[Docket No. FAA–2018–0479; Product Identifier 2016–NE–23–AD]

Airworthiness Directives; Honeywell International Inc. Turboprop and Turboshaft Engines

ACTION: Notice of proposed rulemaking (NPRM).

Figure 1 to Paragraph (h) of this AD. Combustion Chamber Case Assembly Without the One-Piece Bleed Pad with P3 Boss

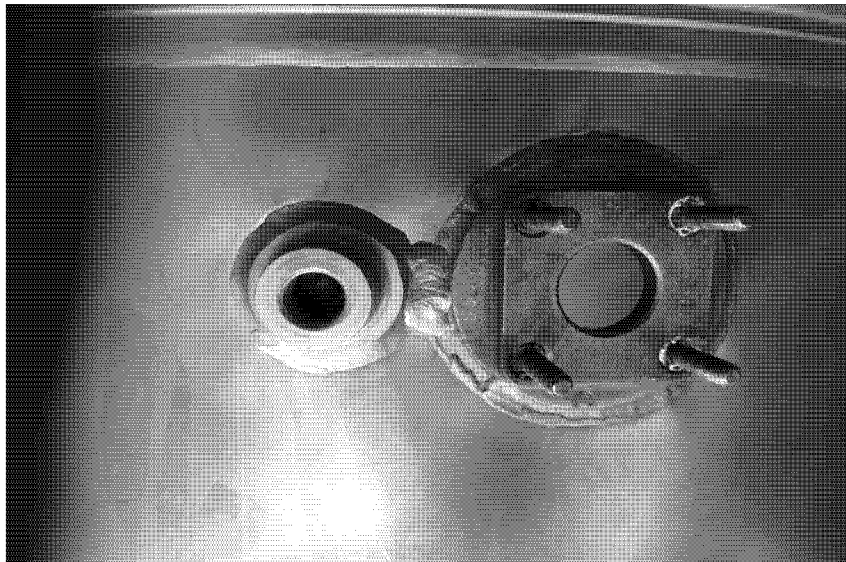
(2) Figures 1 and 2 to paragraph (h) of this AD illustrate the appearance of combustion chamber case assembly, P/N 893973–5, without and with, respectively, the one-piece bleed pad with the P3 boss.

After the effective date of this AD, do not install a combustion chamber case assembly, P/N 869728-1, 869728-3, or 893973-5, in TPE331-3U, -3UW, -5, -5A, -5AB, -5B, -6, and -6A engine models or in TPE331-1, -2, and -2UA engine models modified by National Flight Services, Inc., STC SE383CH, unless the combustion chamber case assembly has a one-piece bleed pad with P3 boss.
